**STATE ENVIRONMENTAL QUALITY REVIEW
(SEQR)**

**FINAL
GENERIC ENVIRONMENTAL IMPACT STATEMENT
(FGEIS)**

**PROPOSED ACTION:
MIDTOWN REDEVELOPMENT PROJECT**

February 20, 2009

Figure 7.1
MIDTOWN REDEVELOPMENT PROJECT
CITY OF ROCHESTER
PROPOSED SITE PLAN WITH ATRIUM & TOWER

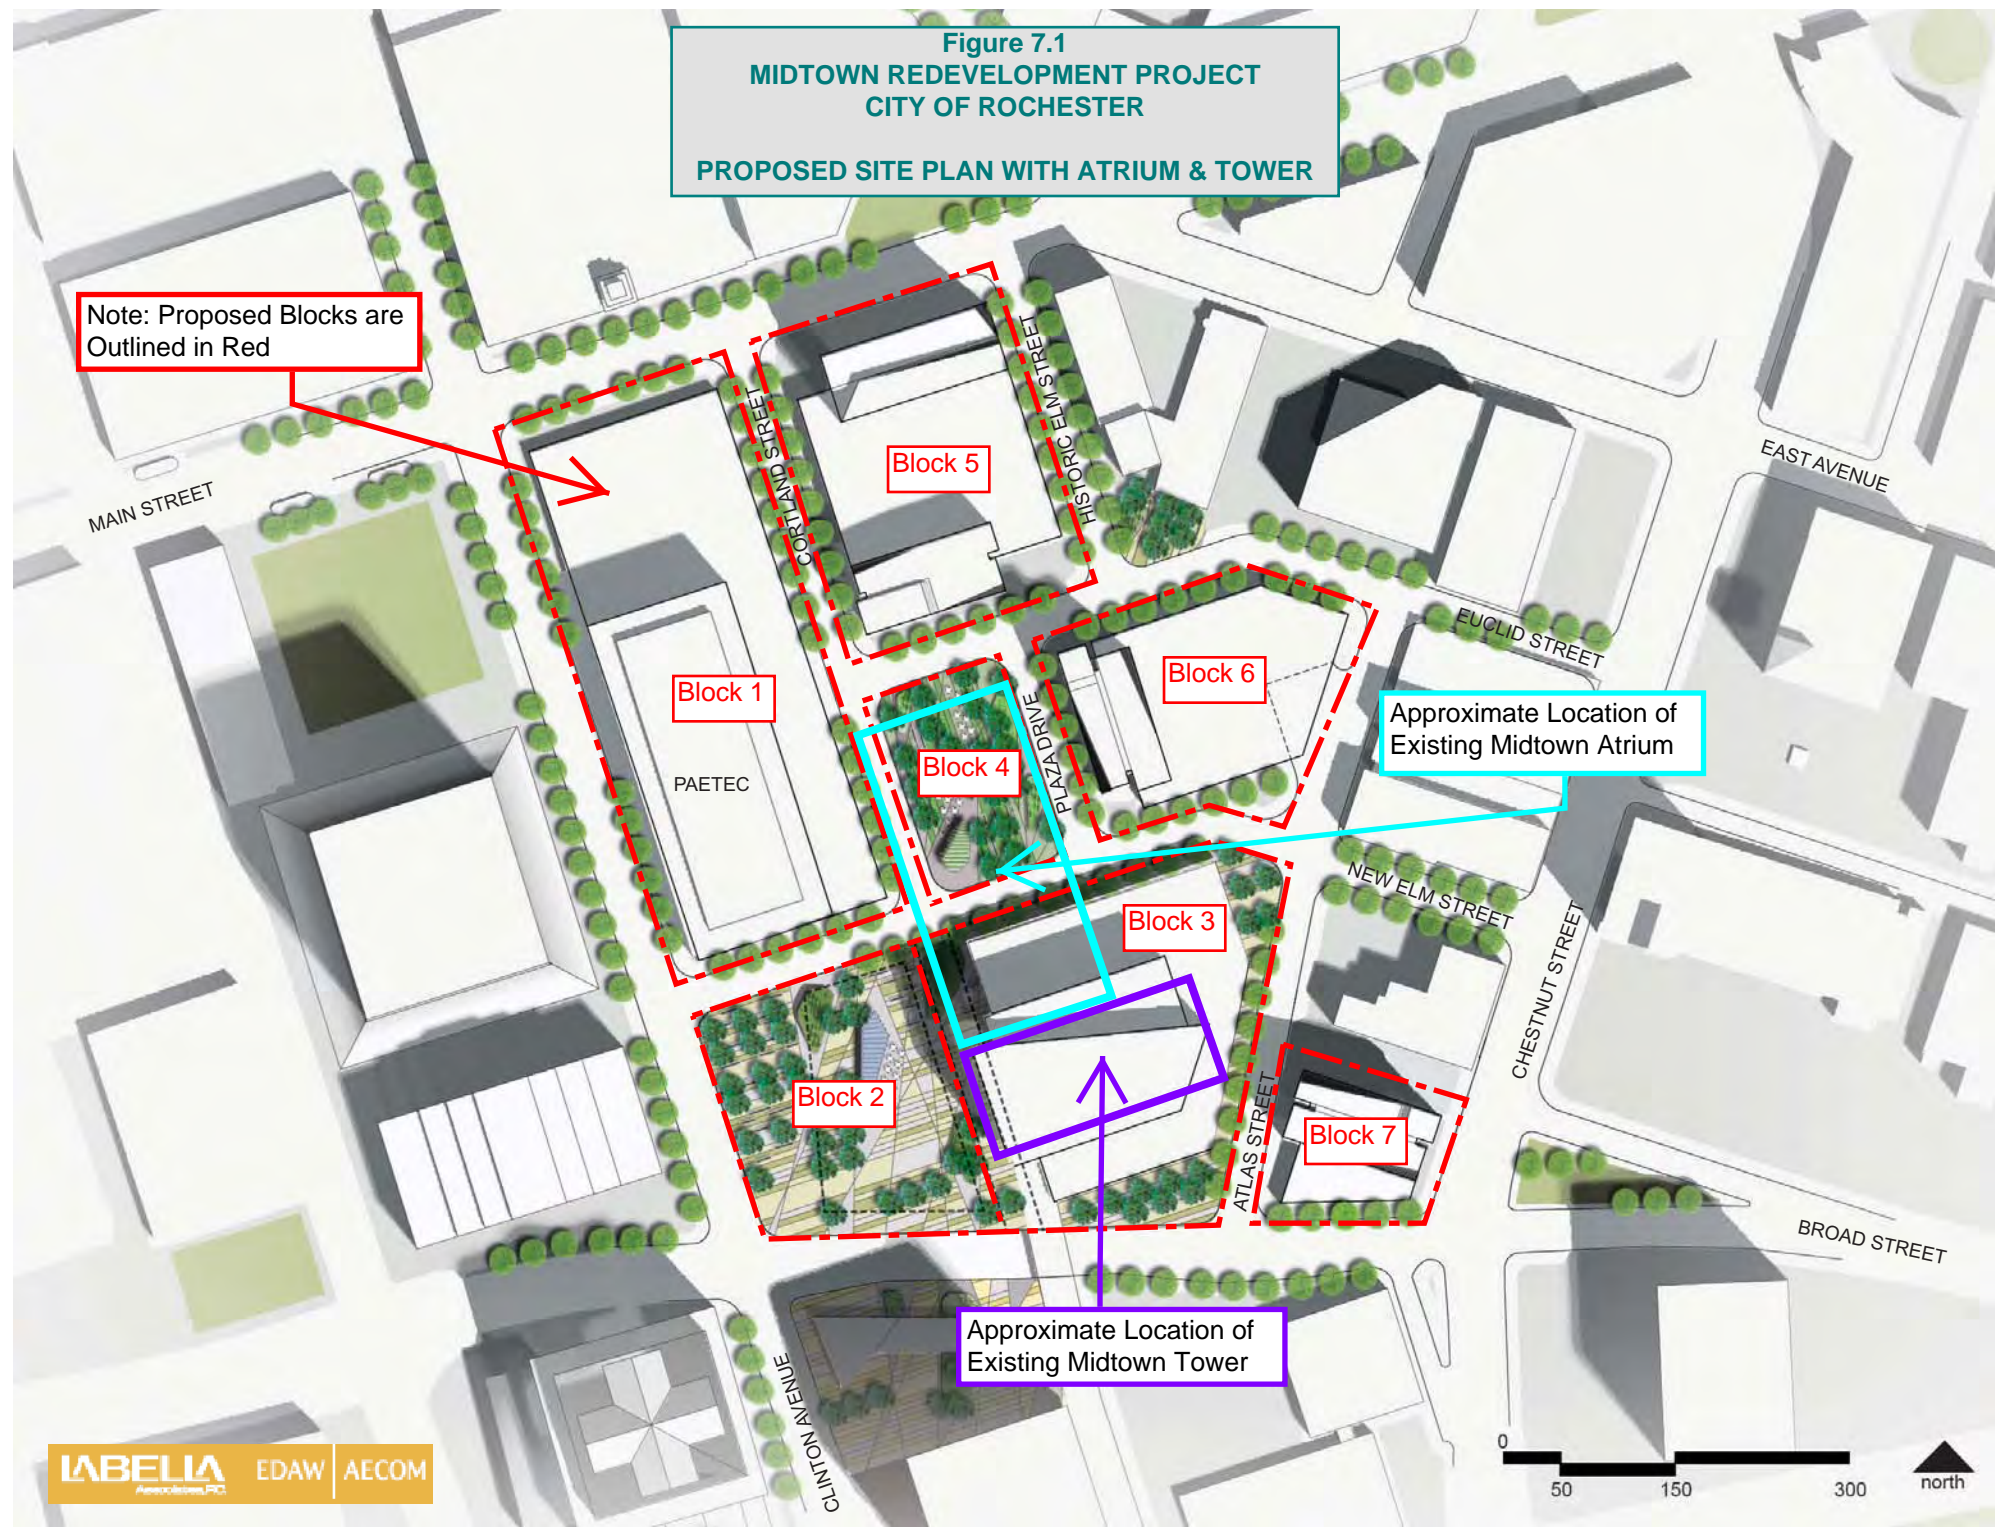
The commenter’s opinion is noted. The proposed site plan (included as Figure A1 in the DGEIS

Please see included Figure 7.1 which illustrates the spatial relationship between the proposed site plan and features the existing Midtown Tower and the Atrium.

and also included herein as Figure 7.1) shows a preliminary design for introducing a new street grid along with pedestrian circulation which will accomplish the City of Rochester's goal of breaking up the Midtown "Super Block". As set forth in the City of Rochester's Center City Master Plan, the site plan supports a development objective which will reduce the "barrier effect" and negative impacts of both natural and man-made physical features. Section 5C of the Center City Master Plan states that a development objective of the Center City Plan is to "tie neighborhoods or districts together that have been separated by physical development, infrastructure, design elements or natural features, by improving circulation routes, changing land use or street patterns or developing new design elements". Overall, the proposed site plan encourages a more sustainable pedestrian use and effectively reconnects and reactivates the adjacent areas. To review Campaign Ten of the Center City Master Plan (Rochester 2010: The Renaissance Plan) see Appendix K in the DGEIS.

Figure 7.2
MIDTOWN REDEVELOPMENT PROJECT
CITY OF ROCHESTER

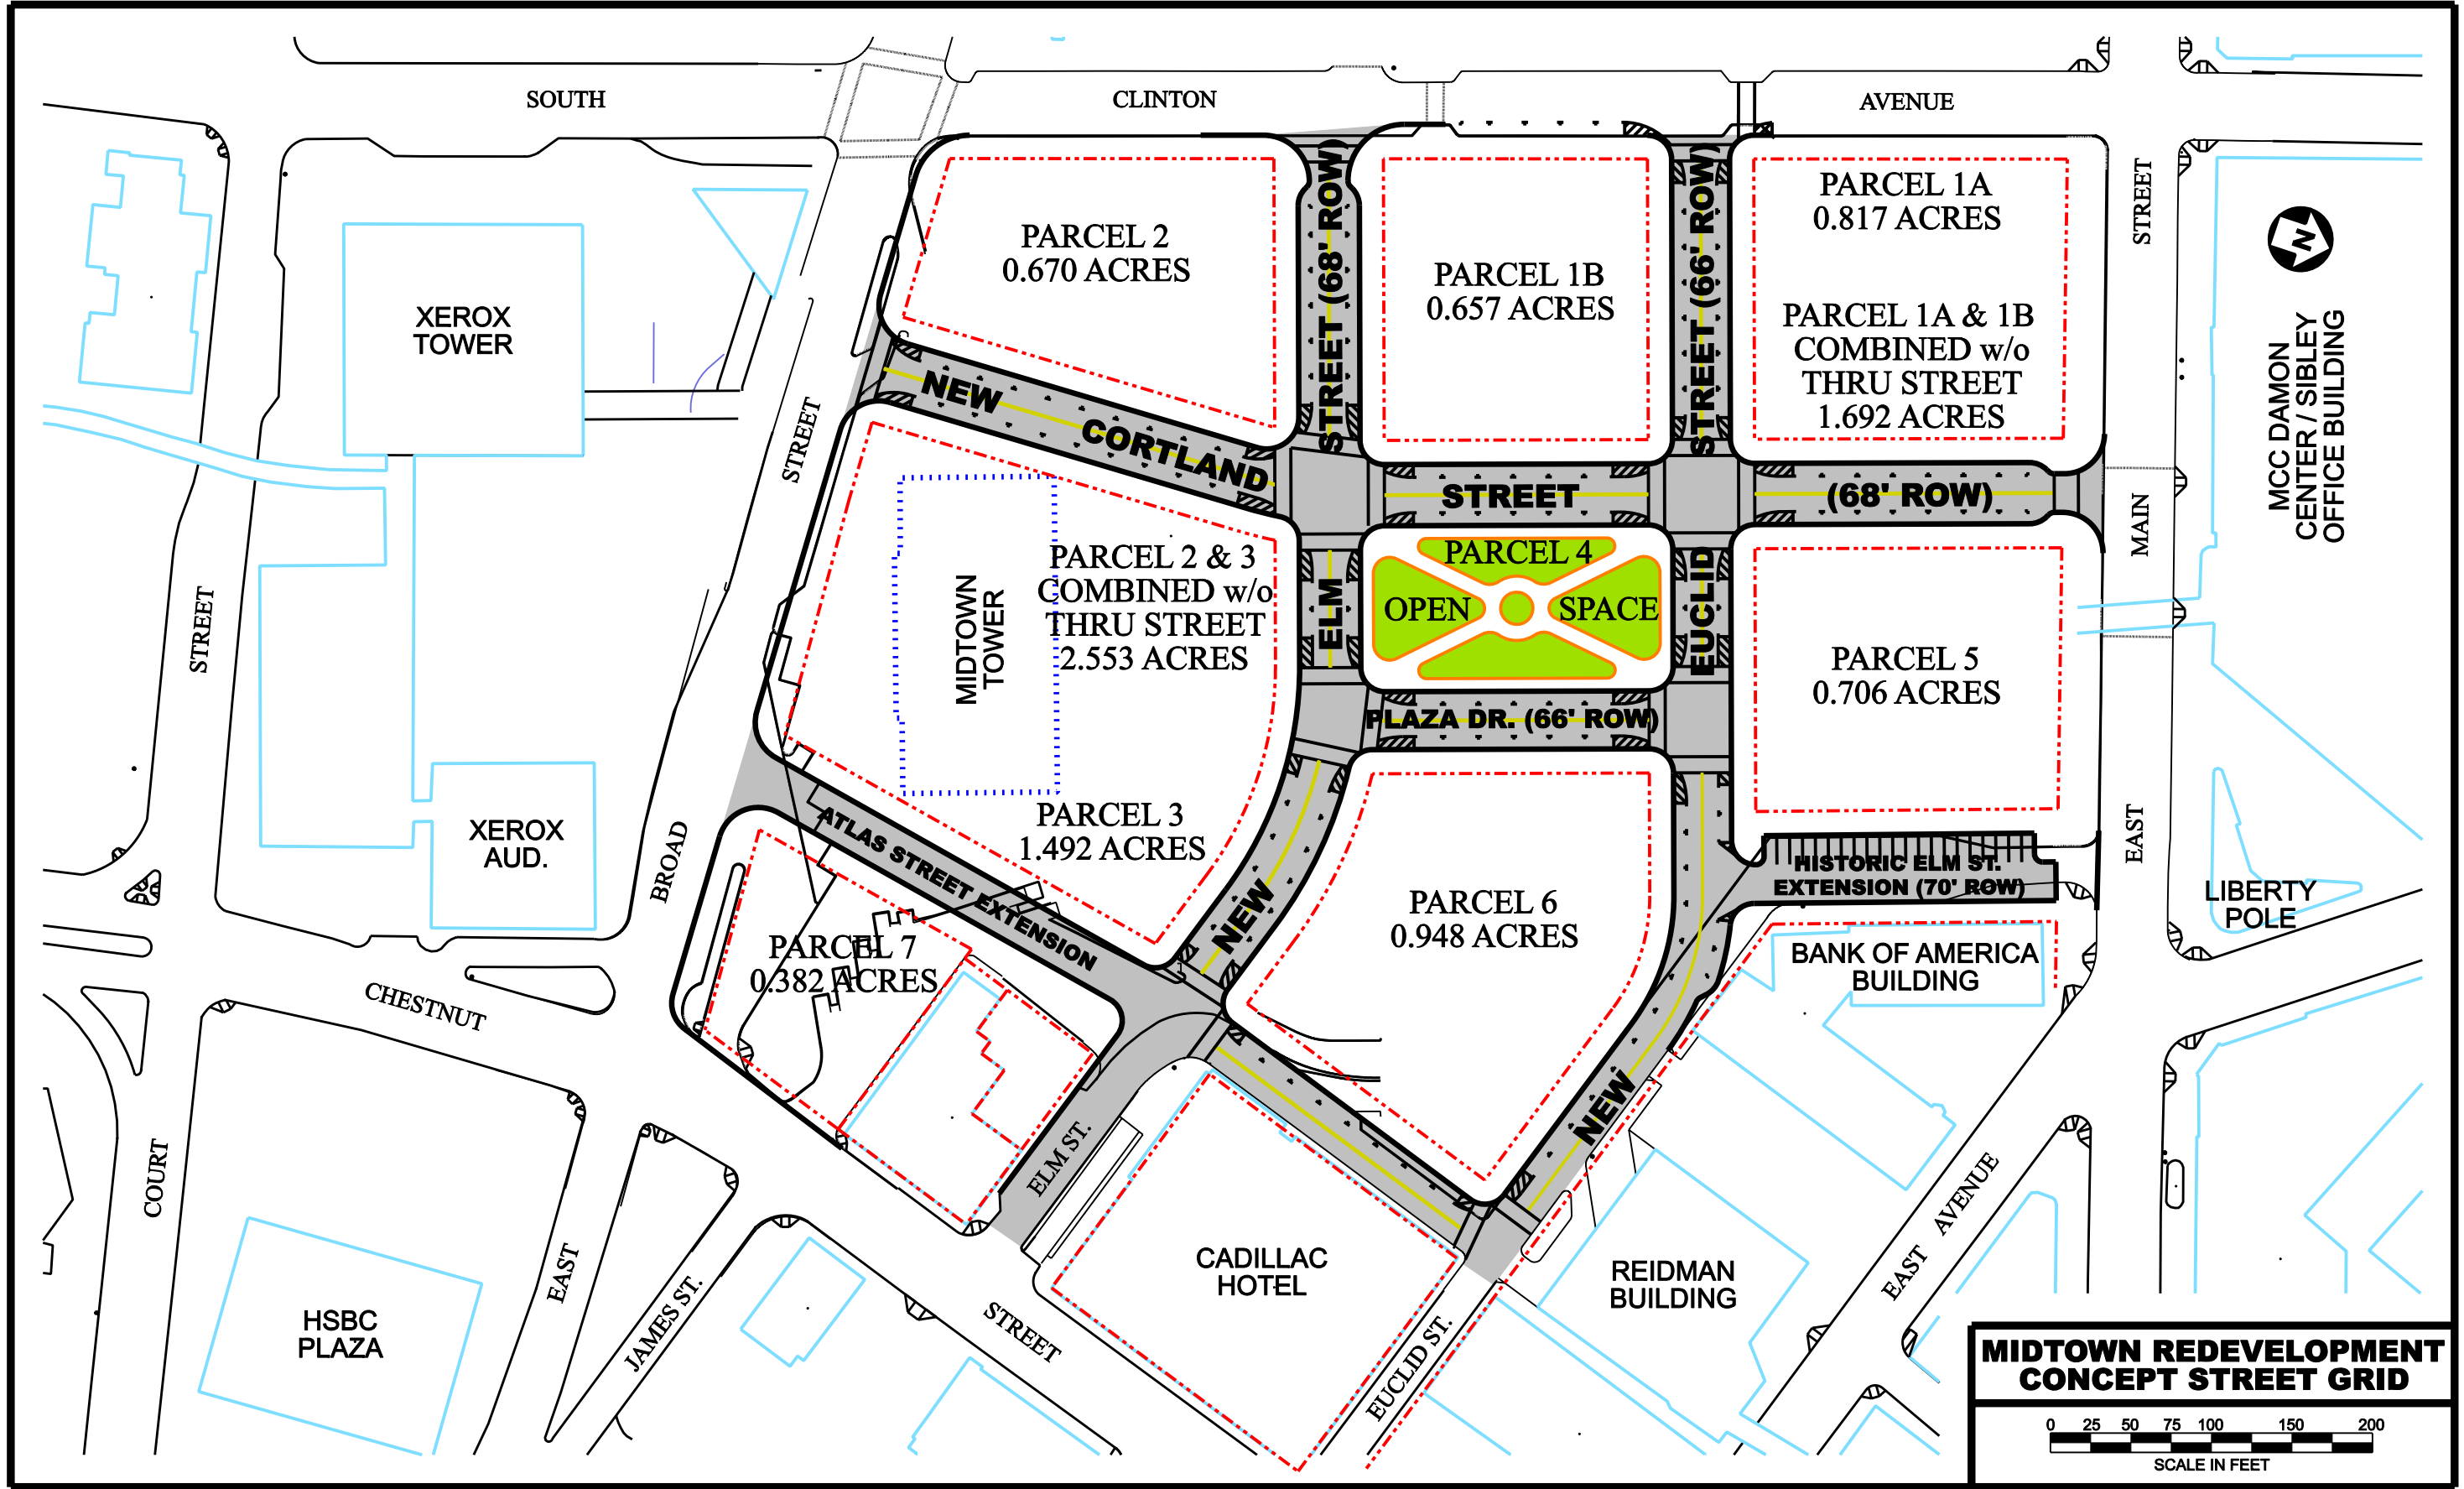
The commenter's suggestion is noted. Please refer to the included figures, Figure 7.1 and 7.2 which illustrate a centrally located outdoor open space. Further information on Massing and Public Realm Guidelines can be found in Appendix D of the DGEIS; the central open space is referred to as "Block #4".

According to EDAW, the character of the public spaces at the center of the block will reflect the land uses that are located there. In this case, the center of the block is a combination of residential and commercial uses, with retail lining the perimeter. The plaza we indicate in the plans does in fact fit the description from the above comment as indicated in the rendering depicting this space (see Figure 7.2 appended to the end of this document).
